Gate Burton Energy Park EN010131

Outline Design Principles (Change Request Version)
Document Reference: EN010131/APP/2.3

Revision <u>54</u> October 2023

Environmental Parameters Plan

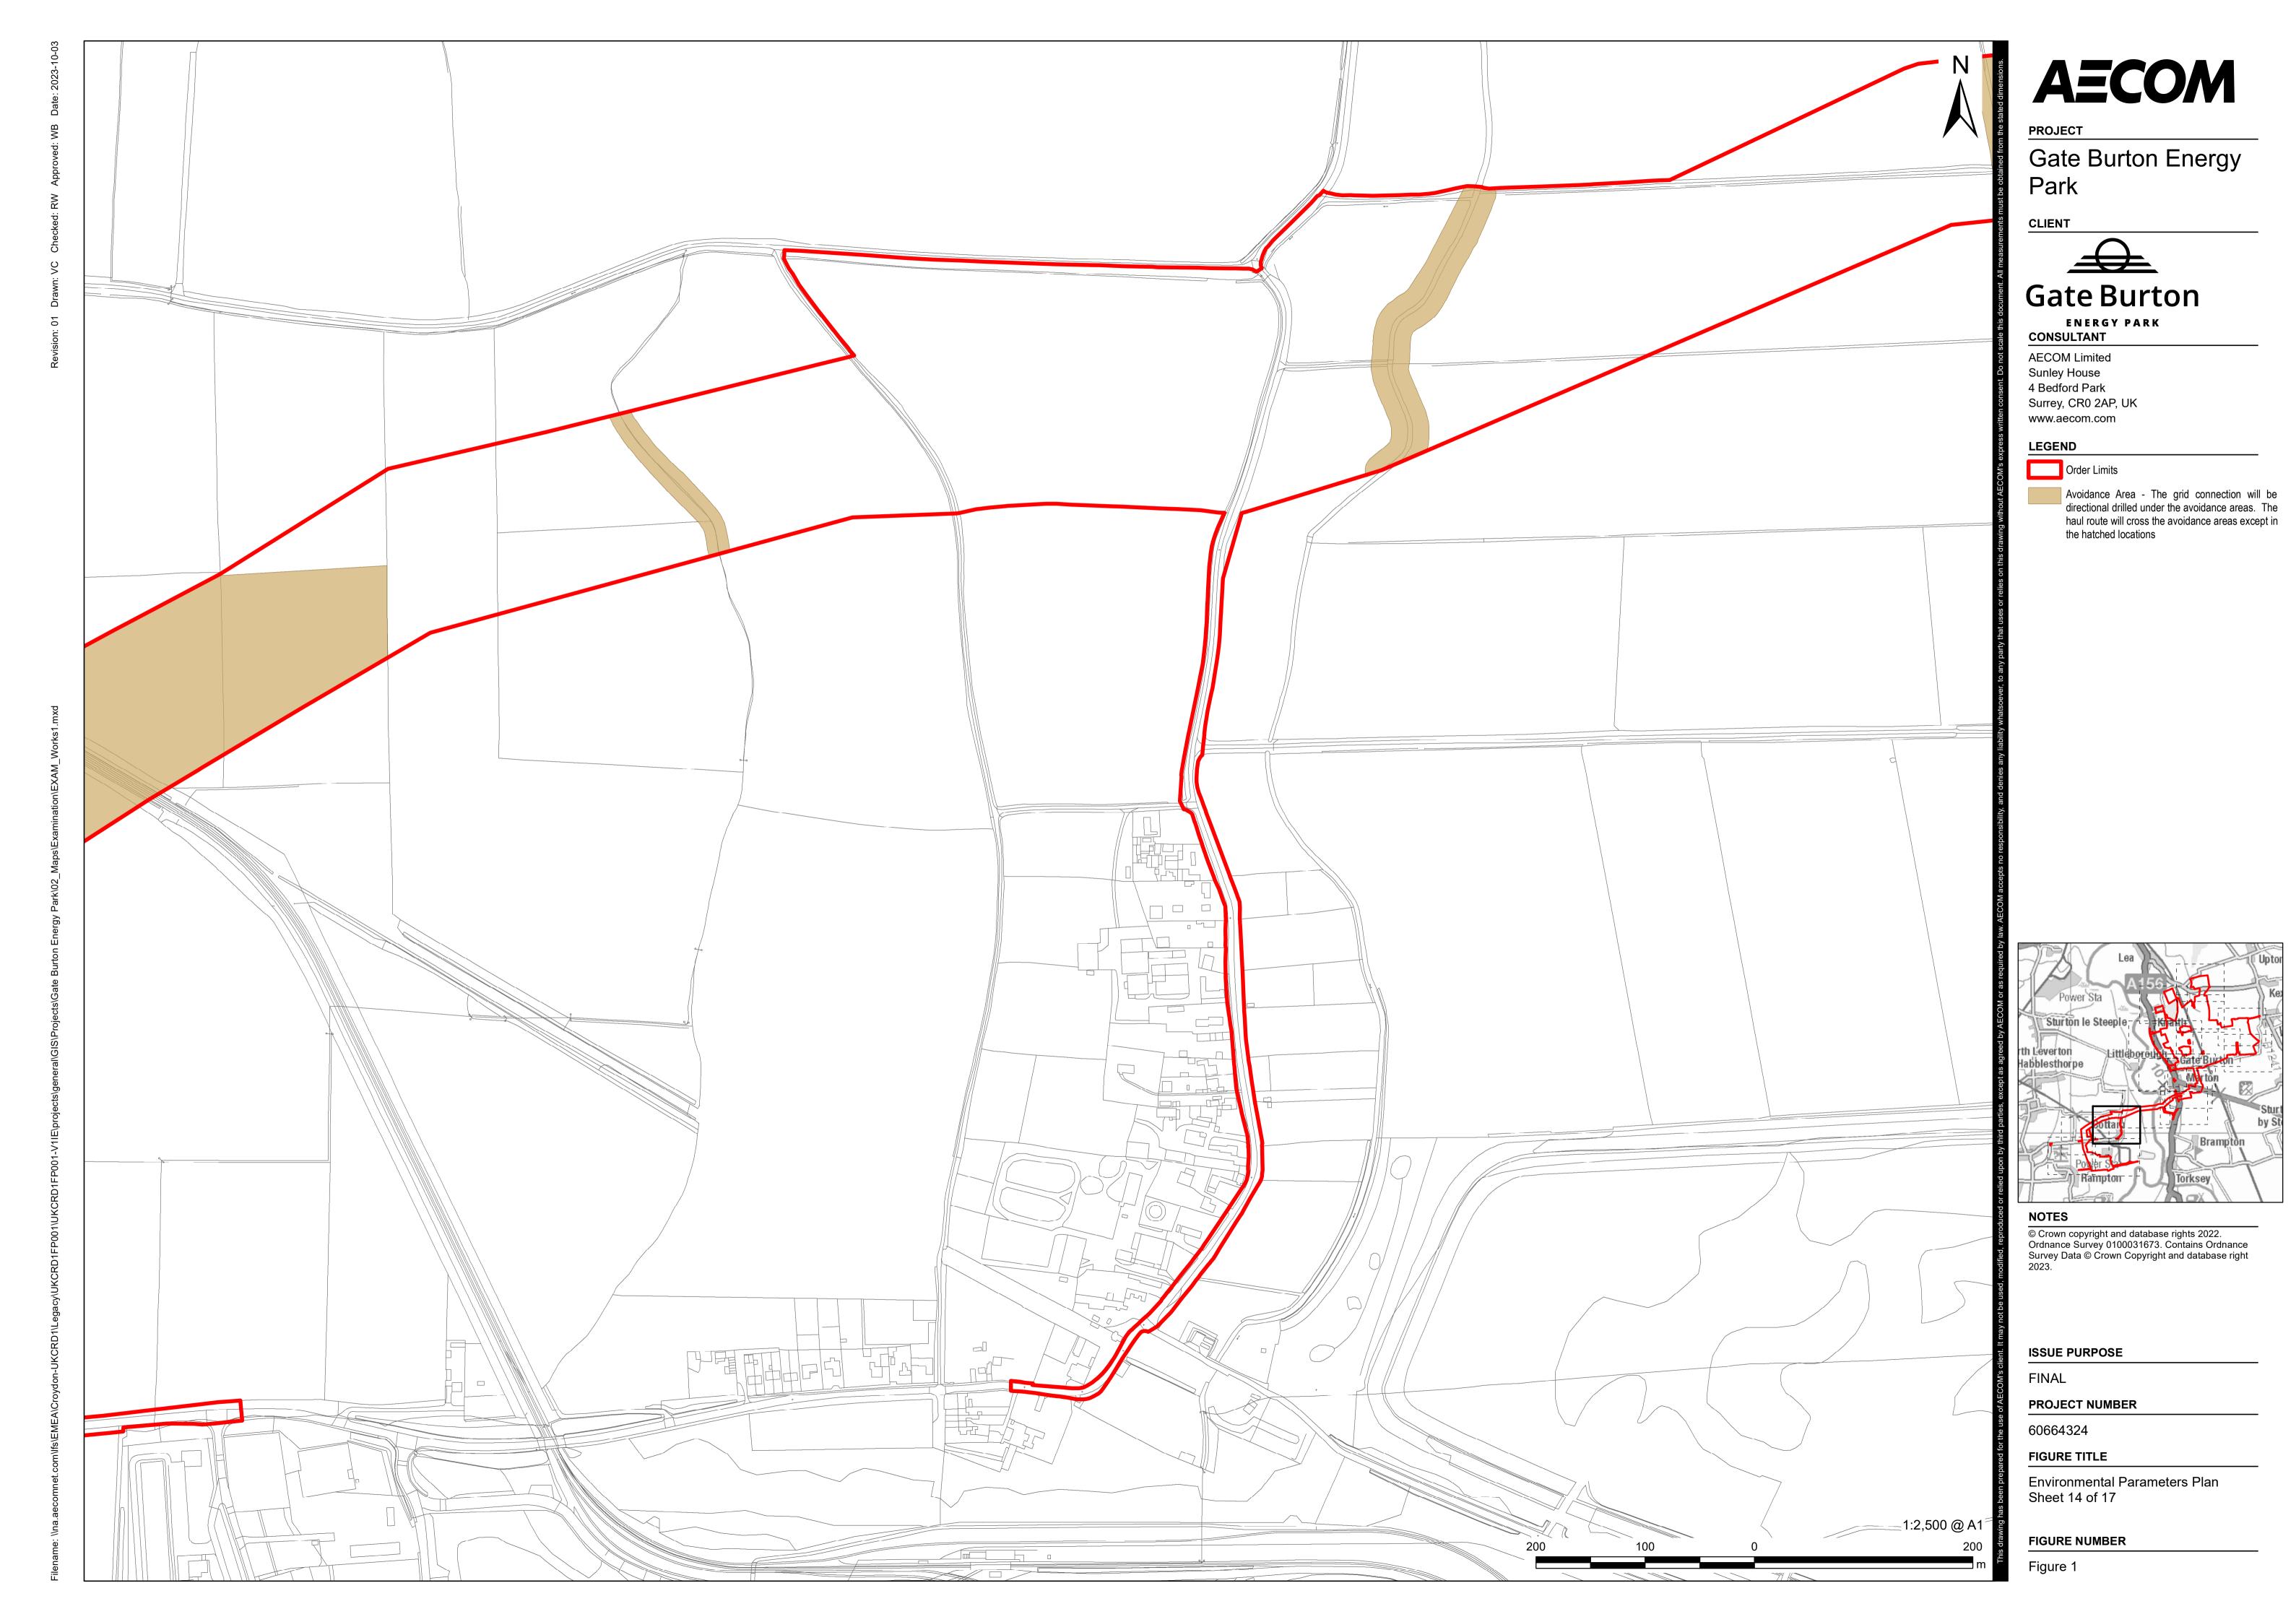
1.1.4 As part of design development, the location of the water tanks have been relocated such that they are adjacent to the access road, at the request of Lincolnshire Fire and Rescue Service. The new locations are outside the area that may be affected by the prevailing wind direction. The Parameter Plan Figure has been amended to include the additional areas for the water tanks. The maximum height of the water tanks is 4.57m. The northern water tank is adjacent to the BESS envelope which has a maximum height of 4.5m. The southern water tank is adjacent to the substation envelope which has a maximum height of 13m. The relevant environmental assessments (landscape and visual, ecology and nature conservation, water environment and cultural heritage) have reviewed the change The change does not have an impact on the conclusions of the assessments as set out within the Environmental Statement.
